800 STEWART

EARLY DESIGN GUIDANCE 2

SDCI#3034006-EG

11.05.2019

PODIUM MASSING RESPONSE DIAGRAM

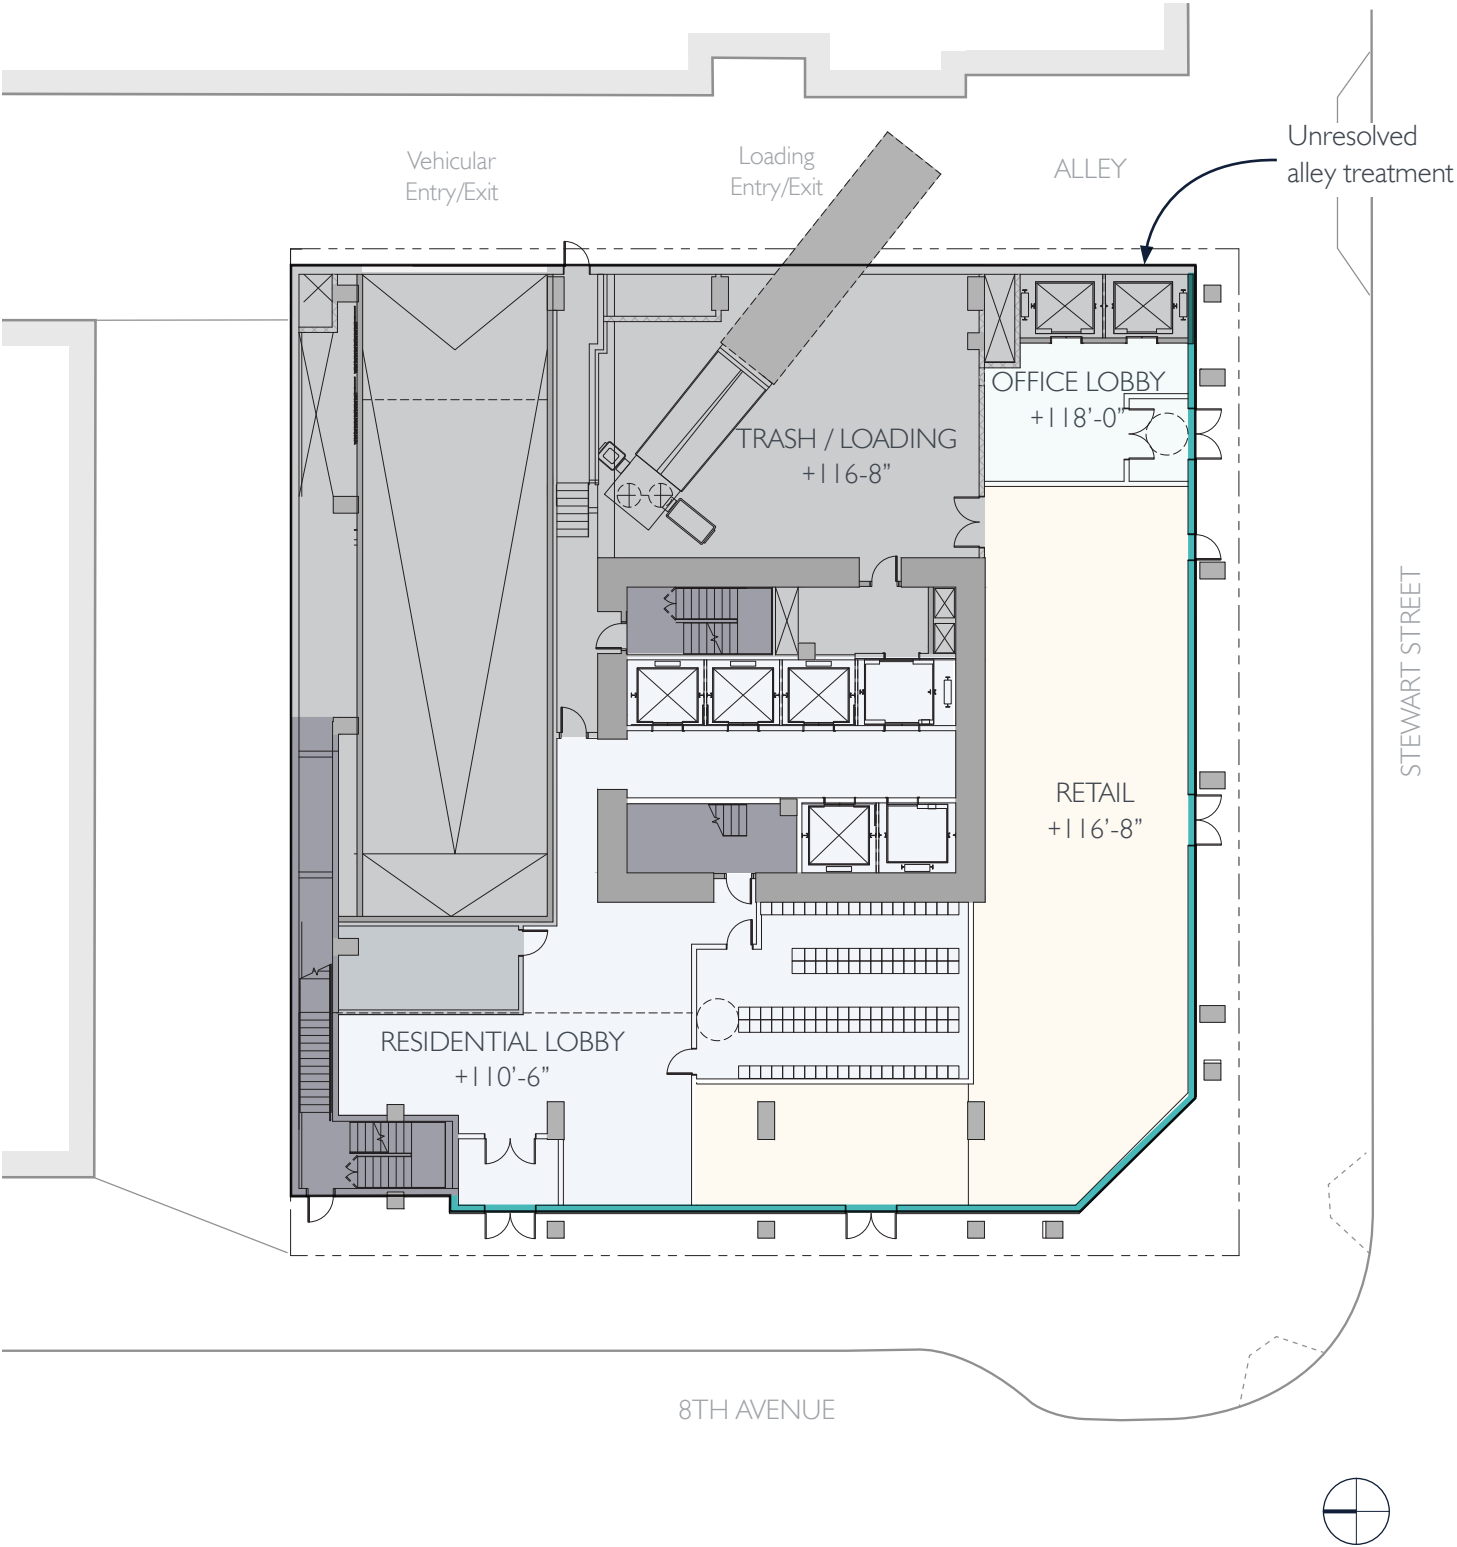
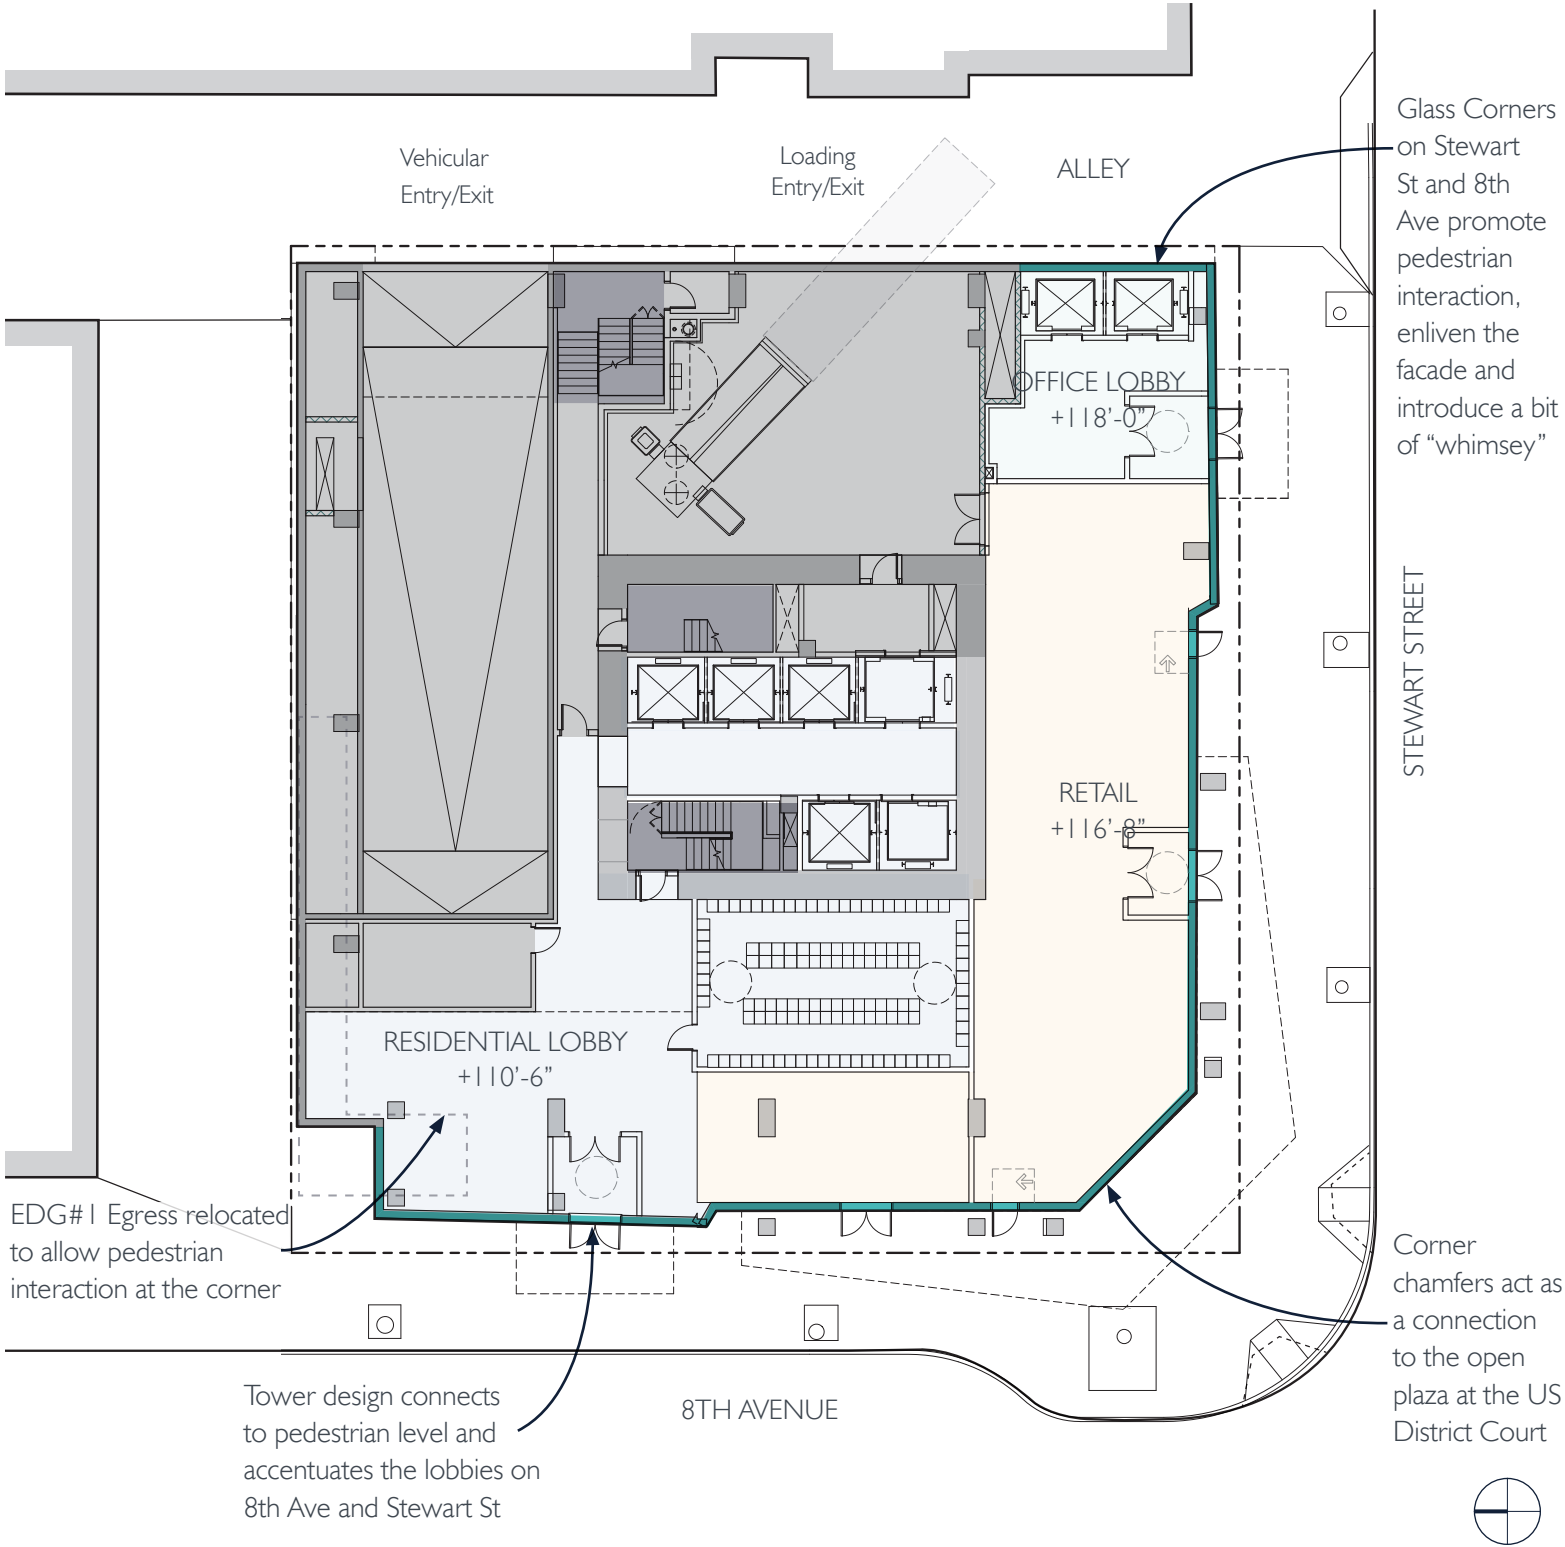
The Board agreed that there were many approaches to strengthening this design concept that could be successful, and asked the design team to specifically demonstrate responses to the following possibilities at the next EDG meeting: Exploration of how the Refract concept could be better integrated with the base, ideally strengthening the expression of both. (B-4, A-1)

The Board agreed that the base expression appeared unresolved and disconnected from the larger design concept and would require further development, with consideration for how this is resolved at the alley. (D-3, C-1, C-2)

The Board noted how the dynamic tower massing in many of the precedents were carried completely down to grade and asked the design team to explore a similar option, ideally with the folds and chamfers from above identifying important programmatic elements at street level. (B-3, B-4)

The design team has modified the design in order to bring the “shoulders”, and deeply inset the tower down to grade, allowing the Southwest corner to be elevated creating a strong architectural expression and urban response. This massing change accomplishes several goals: First it grounds the design by physically bringing a portion of the tower down to the ground. Second it contrasts against the elevated Southwest corner creating a stronger architectural expression. Third it further differentiates and reinforces building entrances and programmatic uses – the massing shifts in plane between residential, retail and office entrances.

The corner of 8th and Stewart is lifted to create a more dramatic architectural expression and to respond to the open space across the street

“Fold” in the tower is brought down to meet the ground on two corners, while also highlighting and differentiating entrances.

Podium wall set back to give prominence to the glass structure and to express corner of the tower

TOP OF TOWER MASSING STUDIES

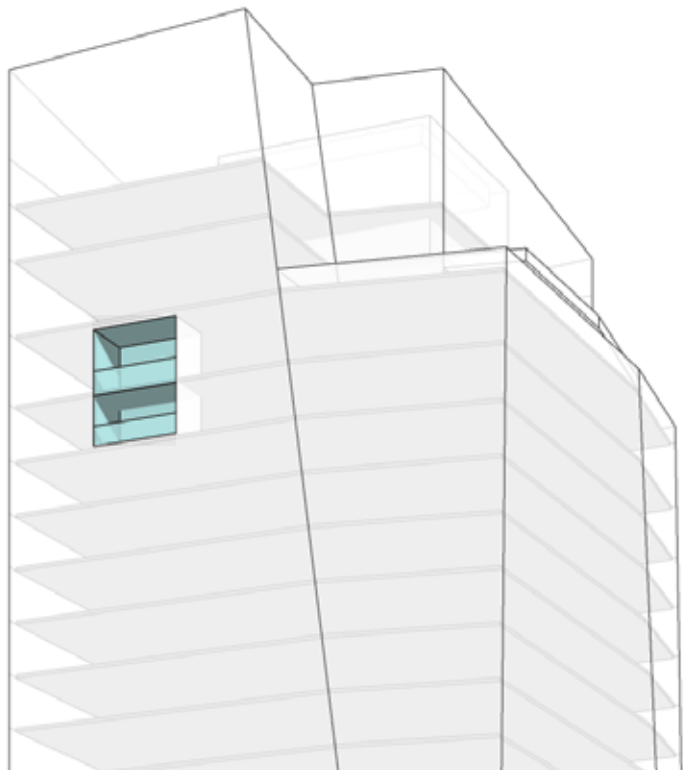
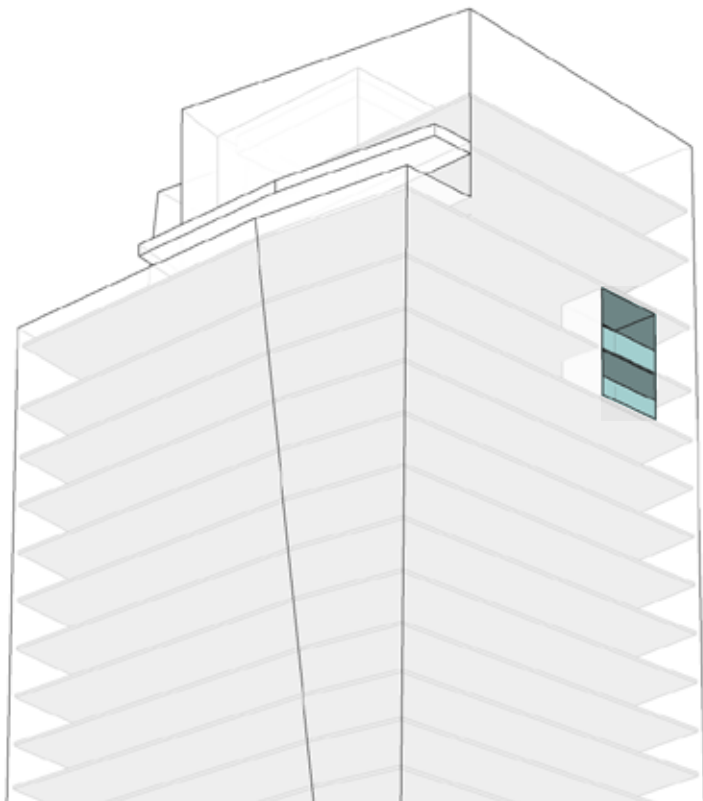
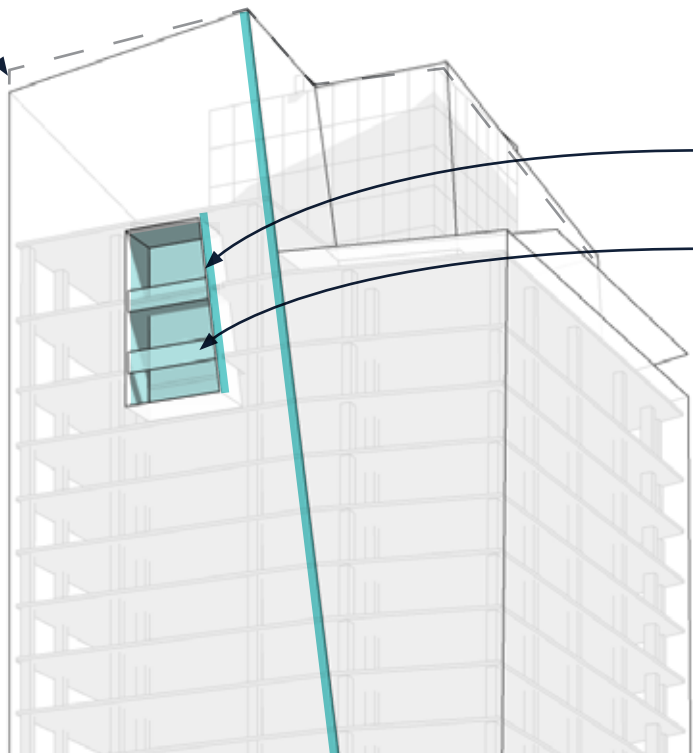
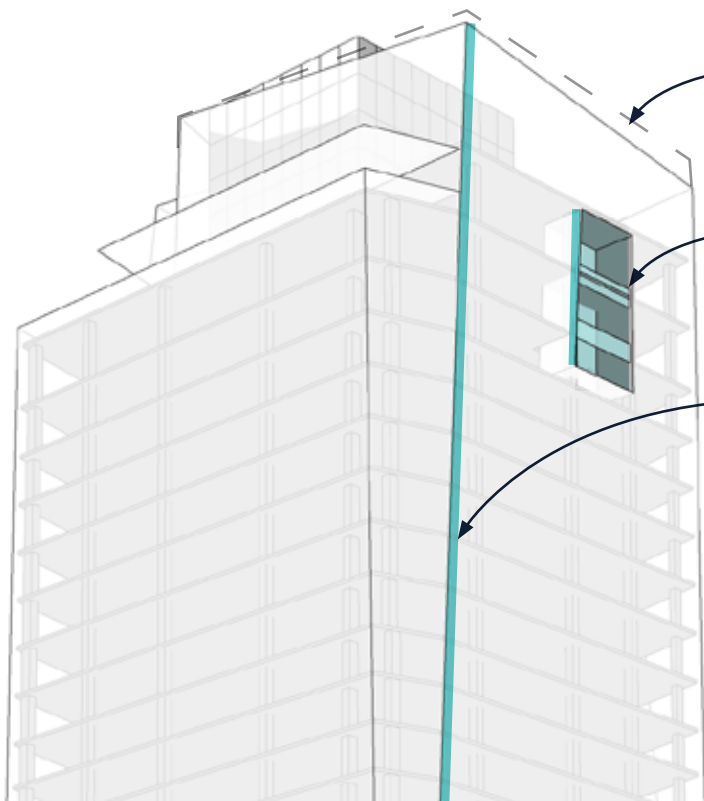
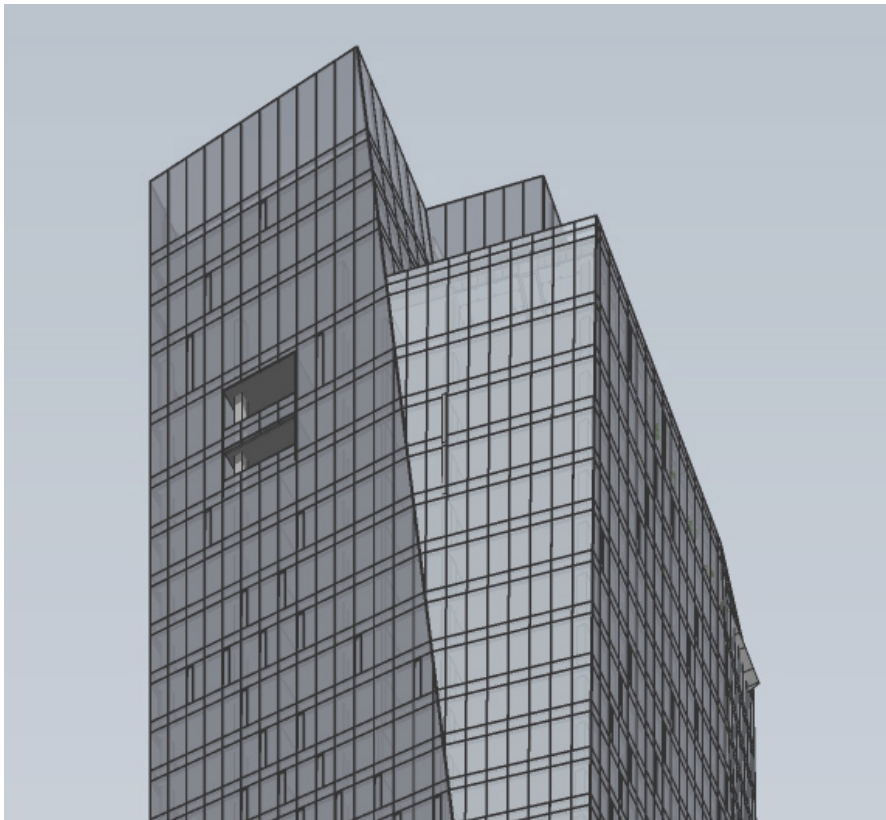
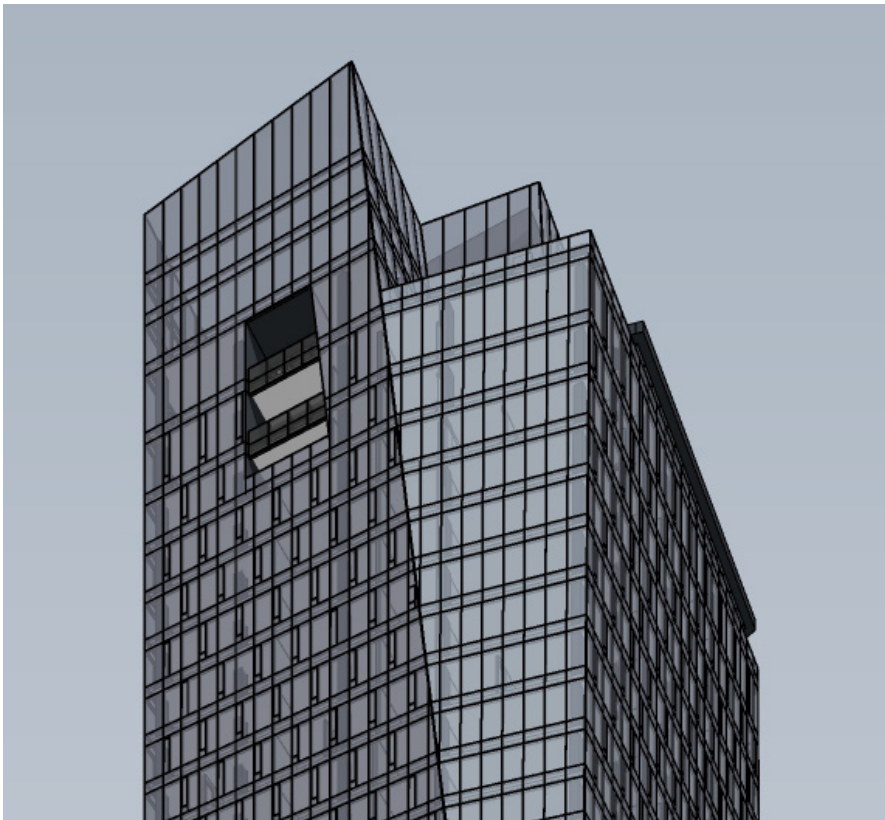
The Board agreed that there were many approaches to strengthening this design concept that could be successful, and asked the design team to specifically demonstrate responses to the following possibilities at the next EDG meeting: The Board agreed that punched openings near the top of the tower were an intriguing design component and asked the applicant to explore further options in their configuration and expression that would strengthen the design concept. (B-4, A-2)

Exploration of a variety of options for the roof, both as a mechanism for strengthening the design concept and as part of a well-proportioned and unified building design. The Board agreed that using the roof form to strengthen the design concept could be particularly important for the relatively weaker elevations. (A-2, B-4)

The design team studied the configuration of the punched openings at the top of the tower. The design has been adjusted so that the side of each opening matches the angle that is created in the massing shifts in the tower, and the proportion of each opening has been heightened to more elegantly respond to the proportion of the overall tower. Lastly, the design team has further refined the material choices in these areas in a more resolved way. All of these changes allow the punched openings to be more integrated in to the overall design of the tower.

Additionally, the design team has adjusted the massing of the tower on select corners so that the top of the tower is more integrated into the overall massing of the tower - eliminating unresolved corners. The design review board commented on the overall success of the resolution at the Southwest corner and the design team has created a similar condition on the Southeast corner in order to more elegantly resolve the massing and enhance the skyline.

Angle of top of tower has been adjusted to increase drama at top of tower and enhance the skyline.

Opening is parallel with the tower chamfer.
Darkening the tint of the glass railing de-emphasizes its appearance in the facade creating a more unified expression.

Angle of top of tower has been adjusted to increase drama at top of tower and enhance the skyline.
Railings are set back from the facade to give definition to the sculptural opening
Massing of corner chamfer adjusted so that the top of tower can be more elegantly resolved.
